2026.06.05_OPW Markup

CLIENT
Limerick 2030

PROJECT
Project Opera Contract D

DRAWING
GA - FIFTH SIXTH FLOOR PLAN

GA - 05-06 - FIFTH AND SIXTH FLOOR
1 : 100

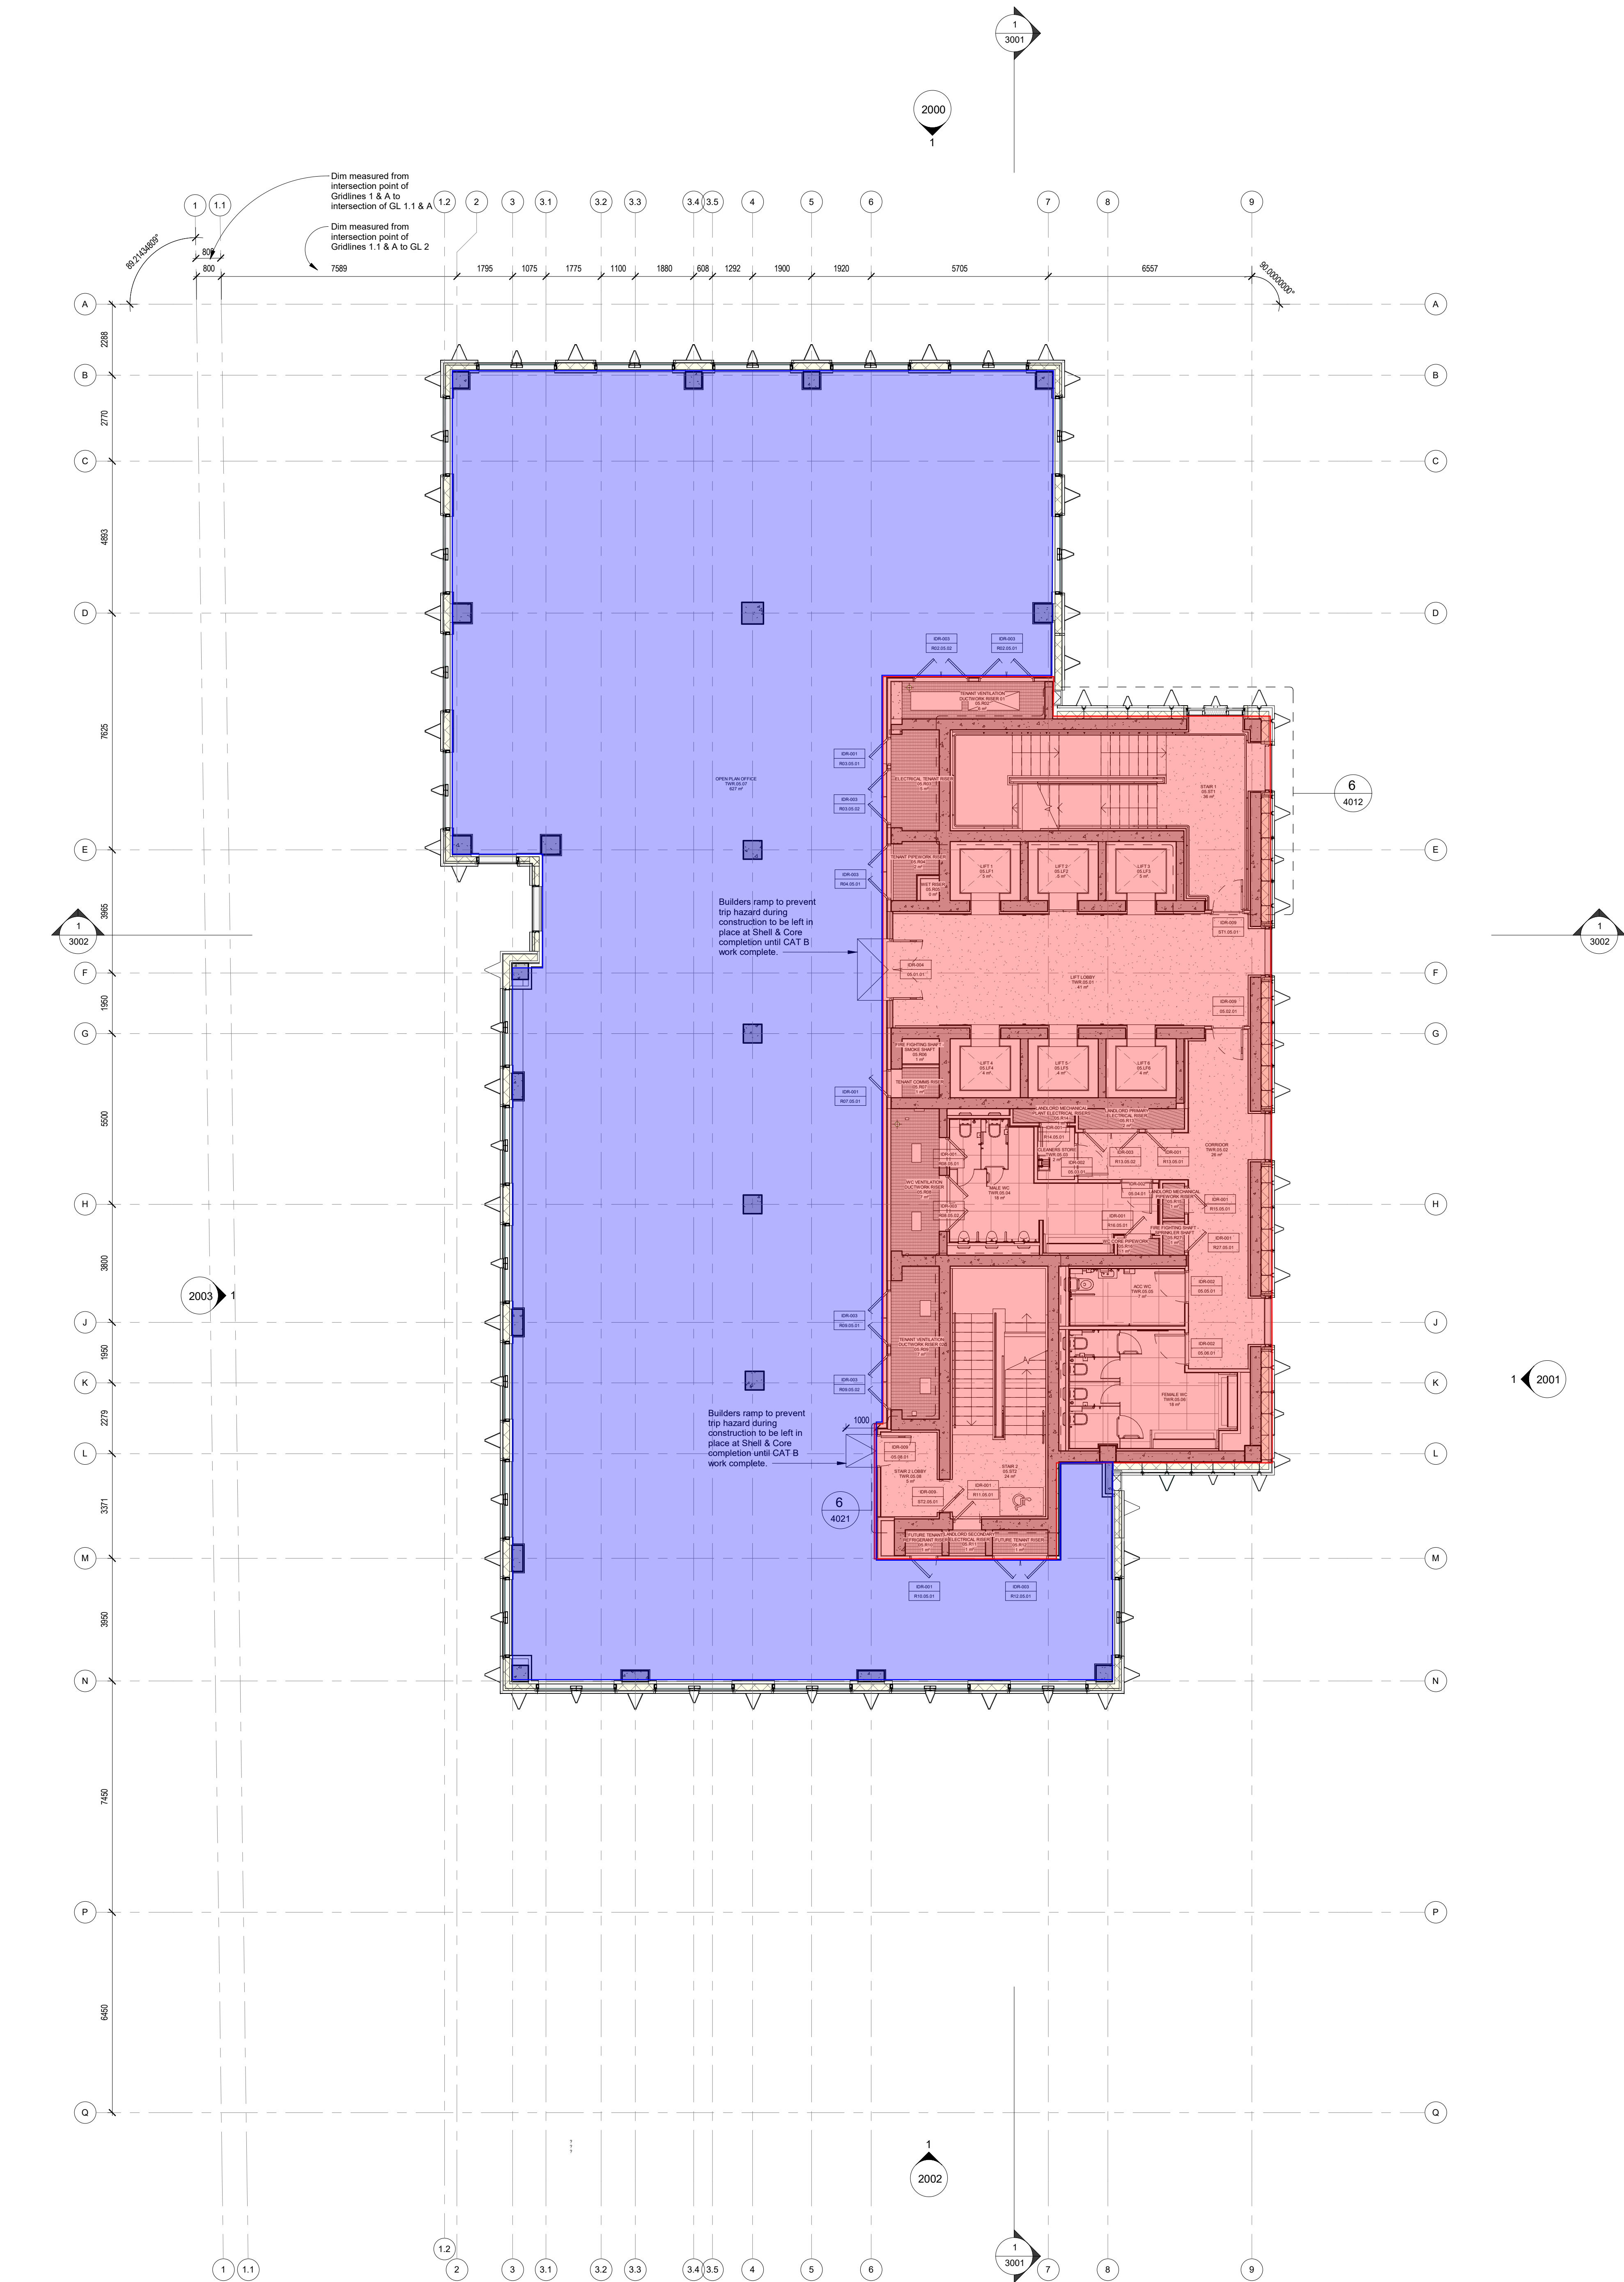
- Landlord areas to be fitted out as part of the Shell + Core works currently on site
- 'Grey box' office areas to be designed and constructed as part of this Fit Out project.

RAISED ACCESS FLOOR INSTALLED AS PART OF TENANT FIT-OUT
